Access Compliance Report

Public Rights-of-Way

(Curb Ramps)

Intersection ID: 9823	Main Street: CONCORDIA_AV	Cross Street: GRIMES_ST	Location: W
ADA ID: AA546D157E10	Ramp Type: Directional1	Initial Pass/Fail: Pass	Overall Compliance: No
Codes/Mitigation Info/Possible Solution			Severity Score: 7.5
			Field Measurements/Component Compliance

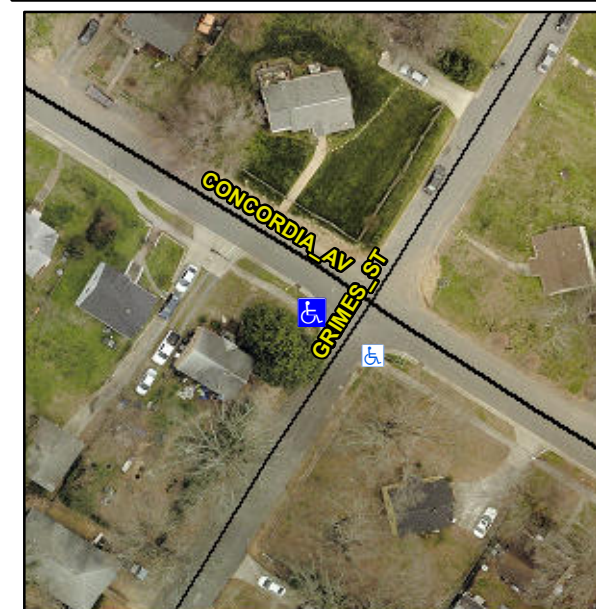
**R304.2.2-Perp, R304.3.2-Para,
R304.5.3, R305.1.4, R305.2, R304.5.4**

Compliance	Description	Data	Compliance	Description	Data
N/A	Ramp Length (in)	120.0	Yes	Grade Break?	Yes
Yes	Ramp Width (in)	57.0	No	Grade Break Slope (%)	6.7
Yes	Ramp Slope (%)	7.5	No	Grade Break XSlope (%)	2.2
Yes	Ramp XSlope (%)	1.7			
Yes	Flare Type LT	N/A	Yes	Flare Type RT	N/A
N/A	Flare Slope LT (%)	N/A	N/A	Flare Slope RT (%)	N/A
N/A	Flare Traversable LT?	No	N/A	Flare Traversable RT?	No
Yes	Landing Length (in)	59.0	Yes	DWS Provided?	Yes
Yes	Landing Width (in)	57.0	Yes	DWS Contrast?	Yes
No	Landing Slope (%)	4.2	Yes	DWS Length (in)	24.0
Yes	Landing X Slope (%)	2.0	No	DWS Full Width?	No
N/A	Landing Curb? (Y/N)	N/A	Yes	DWS Offset LT (in)	48.0
N/A	Shared Landing?	No	No	DWS Offset RT (in)	8.0
Yes	Gutter Ponding?	No	No	Gutter Slope (%)	5.1
Yes	Gutter Lip Ht (in)	0.0	Yes	Gutter X Slope (%)	1.0
N/A	Painted X Walk1?	No		Road Slope (%)	2.8
	X Walk 1 Direction	To SE		Road X Slope (%)	1.2
	X Walk 1 Width (in)	N/A		Clear Space?	Yes

X Walk 1 Slope (%)	2.8	N/A	Clear Space to XWalk (in)	N/A
	X Walk 1 X Slope (%)	1.2	Yes	Storm Grate/Utility Hazard?	No
N/A	Ramp inside XWalk1?	N/A		Storm Grate/Utility Type	
Yes	Any Obstructions?	No			N/A
	Obstruction Type		Yes	Surface Condition? (G/P)	Good
			N/A	Curb Slope (%)	5.1

**Remove & Replace Entire Ramp.
Remove & Replace Gutter.**
